Generic Evaluation of Feedwater Transients and Small Break Loss-of-Coolant Accidents in Westinghouse-Designed Operating Plants

**Office of
Nuclear Reactor Regulation**

**U.S. Nuclear Regulatory
Commission**

**Bulletins and Orders Task Force
Office of Nuclear Reactor Regulation
U.S. Nuclear Regulatory Commission
Washington, D.C. 20555**

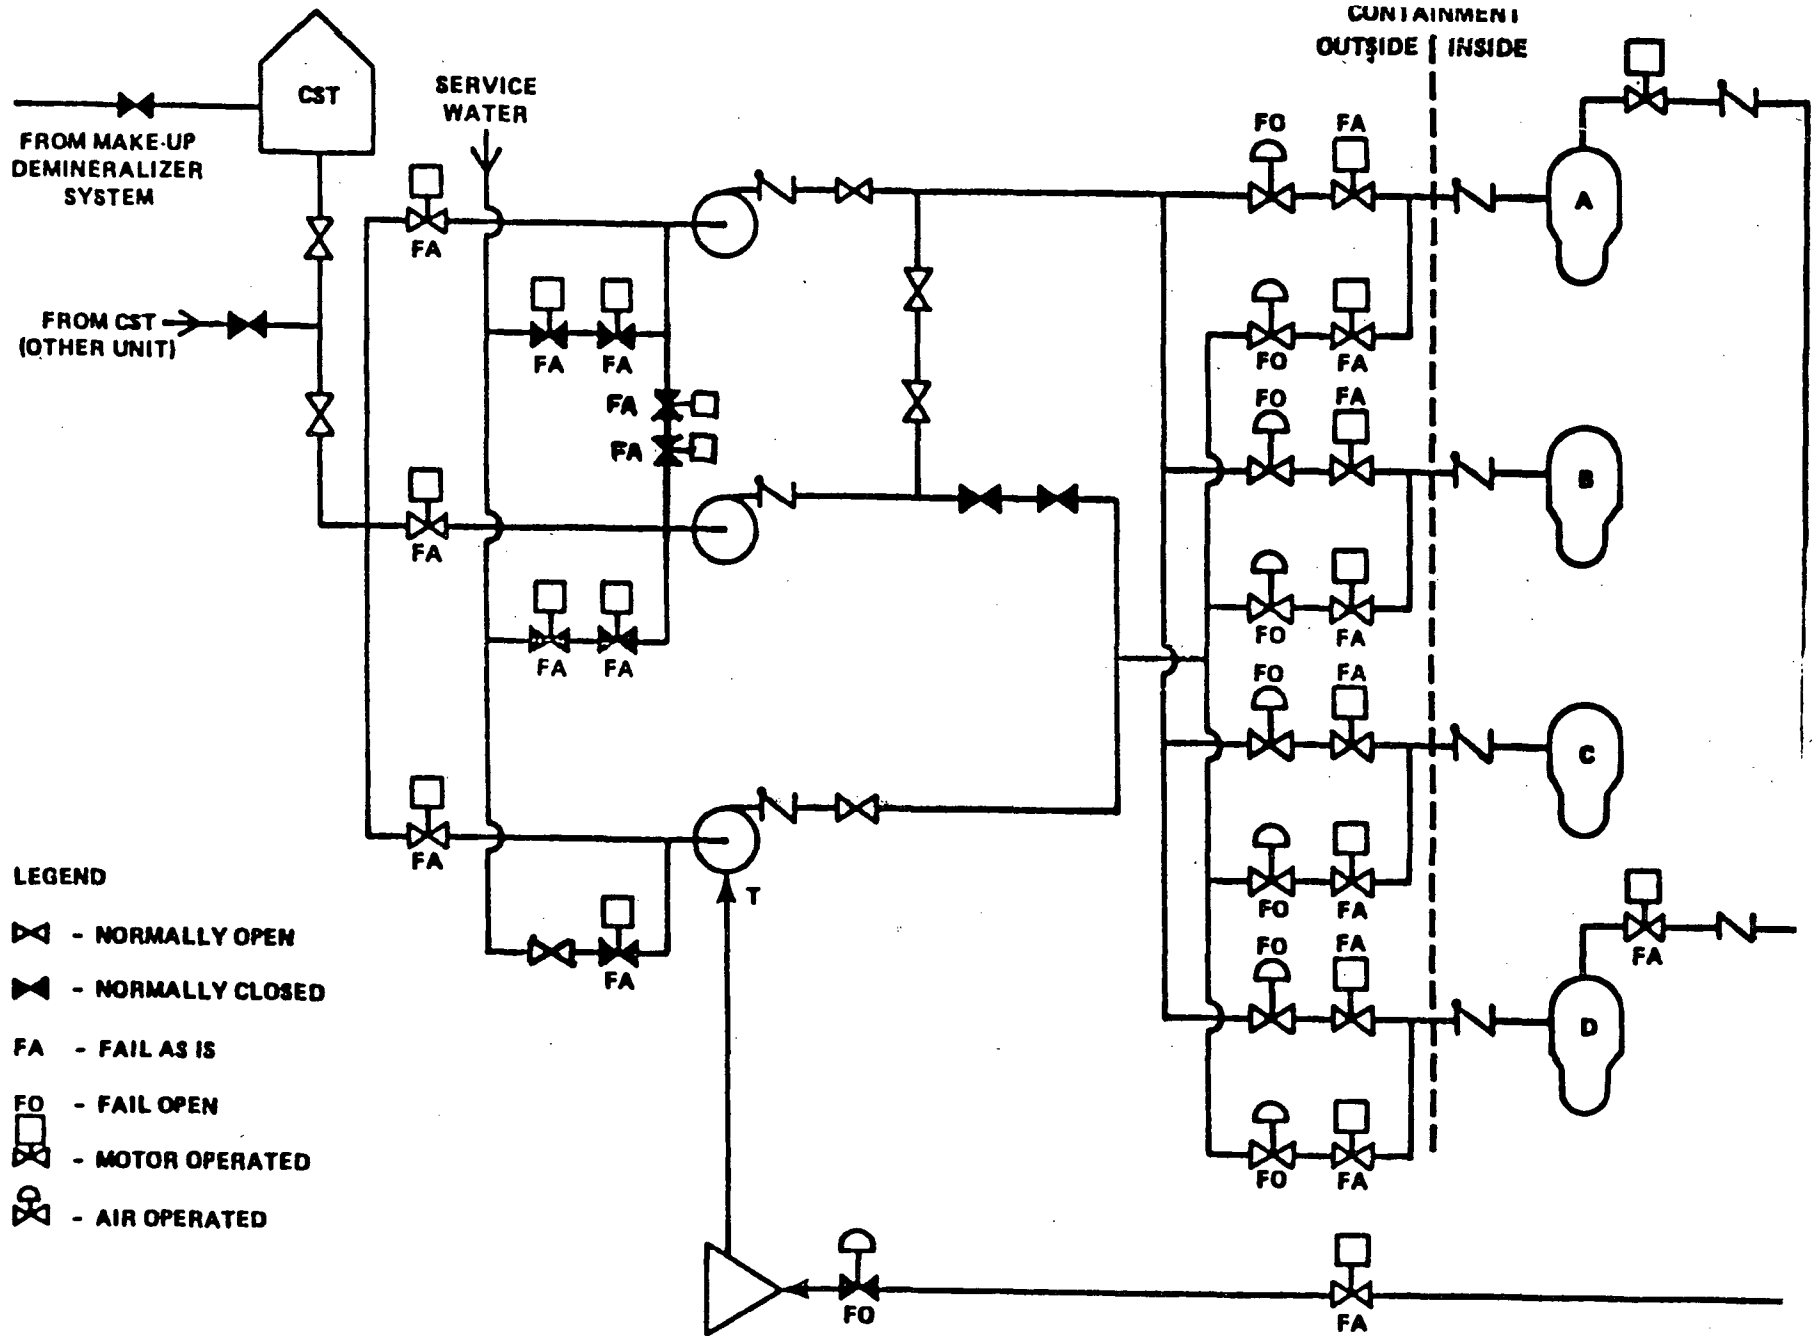
Licensees with plants in which the primary AFW system water supply passes through valves in a single flow path, but the alternate AFW system water supplies connect to the AFW system pump suction piping downstream of the above valve(s), should install redundant valves parallel to the above valve(s) or provide automatic opening of the valve(s) from the alternate water supply upon low pump suction pressure.

The licensee should propose Technical Specifications to incorporate appropriate periodic inspections to verify the valve positions.
